Work Order ID 82865

Item Name: Replacement Skidtube

DRAWING NO. REV. E
D2580 SHEET 1 OF 8
TITLE SCALE
205 SKIDTUBE ASSEMBLY. NTS

DRAWING NO. D2580	TITLE 205 SKIDTUBE ASSEMBLY	REV. E	DART AEROSPACE LTD ENGINEERING ORDER		D.E.O. NO. D2580-E-1	SHEET NO. SHEET 1 OF 1	SCALE NTS
DRAWN <i>UP</i>	CHECKED <i>ASS</i>	MFG. APPR. <i>ER</i>	APPROVED <i>[Signature]</i>		DE APPR. <i>[Signature]</i>		
DATE 11.12.13	DATE 11.12.13	DATE 11.12.13	DATE 11.12.13		DATE 11.12.13

D2580-7 BENT TUBE
(MAKE FROM D2580-101 TUBE)

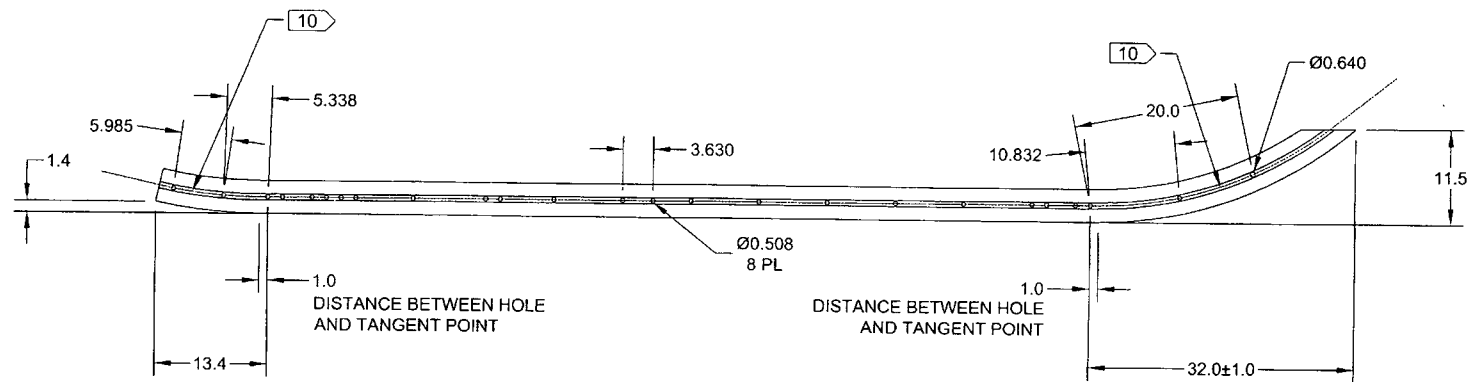
3-Drill pilot holes using DT8149, drill #30 hole (3.630 REF) using DT8149 and SPOT drill #30 (5.338 & 5.985 REF) using DT8149. Open holes to finished size except for (4) AFT spot drilled holes as per dwg D2580 sheet 7.

SECTION B-B, F-F, I-I
NOT TO SCALE

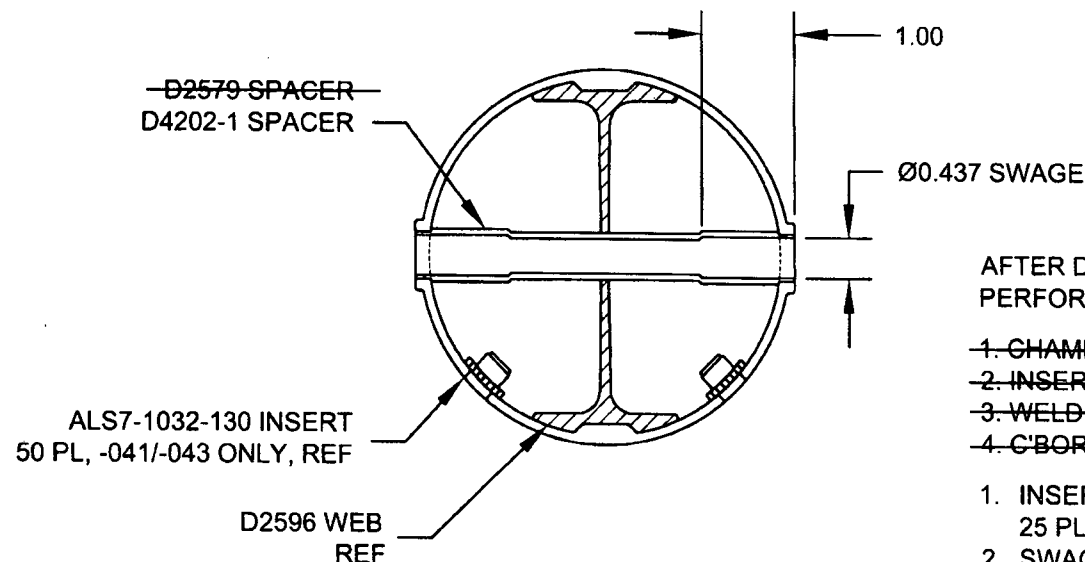
PURPOSE:

CHANGE ALL C'BORED WELDED CROSSBOLT SPACERS TO SWAGED SPACERS

SECTION B-B, SECTION F-F, & SECTION I-I ARE AMENDED AS FOLLOWS
FOR ALL HOLES THAT WERE ORIGINALLY C'BORED:

WELD 4X D2579 SPACERS PER DWG
IN LOCATIONS MARKED "NO C'BORE".
REF SHEET 4 OF DWG.

- ~~1. CHAMFER HOLE 0.050 X 45°~~
- ~~2. INSERT D2579 SPACER (20 PLACES)~~
- ~~3. WELD INTO PLACE AND GRIND FLUSH~~
- ~~4. C'BORE D2579 SPACER TO Ø0.437 X 1.00 DEEP~~

4		* D2579	CROSS BOLT SPACER
20	20	25	D4202-1	SPACER

1. INSERT D4202-1 SPACER, 20 PL (-041) OR 20 PL (-045) OR 25 PL (-047)
2. SWAGE TO Ø0.437 X 1.00 DEEP PER QSI 002
3. TRIM / GRIND FLUSH PER QSI 002
